American Energy Systems, Inc.

## TECHNICAL BULLETIN

Magnum Baby Countryside & Winchester AC/DC Models

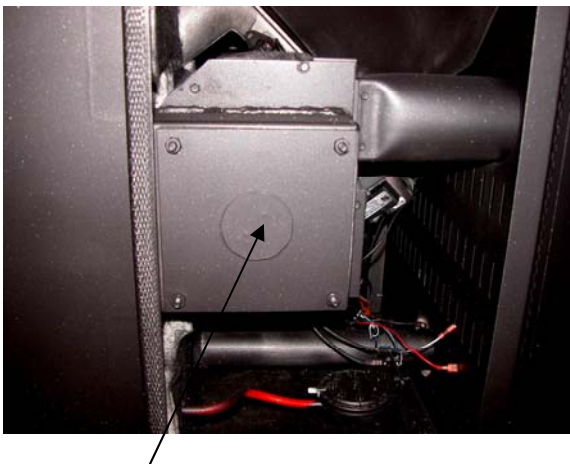
1. Cleanout plug is hard to get off inspection hole on the side of the exhaust manifold housing.
2. Combustion air clean out plug in back of ash pan housing is loose.

1. Cleanout plug on the side of exhaust manifold:
  - a. Open right side panel of unit. (facing the front of the unit)
  - b. Remove cleanout plug with screwdriver and discard.
  - c. Insert new cleanout plug (Part#RP2094) (supplied by dealer)
  - d. Plug power back into unit and re-light.
2. Cleanout plug in back of ash pan housing:
  - a. Open door for ash pan. Remove ash pan
  - b. Check clean out plug, if loose remove, discard and insert new one (Part# RP2094) you can get these from your nearest dealer.
  - c. Plug power back into unit and re-light.

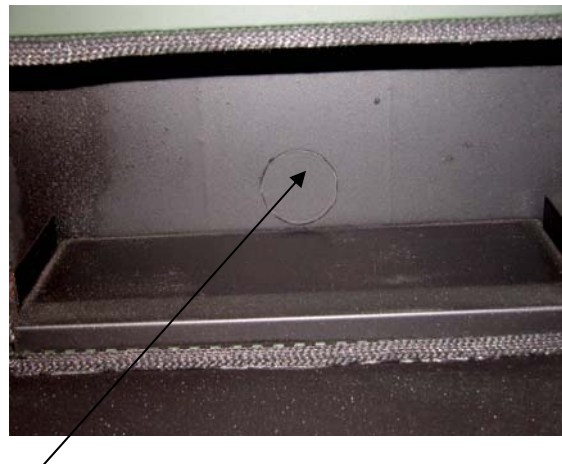
Remove plug with screwdriver and discard  
Replace with new one. Part# RP2094

Check to see if plug is loose. If so, remove with  
screwdriver and discard this plug. Replace with  
new one. Part# RP2094
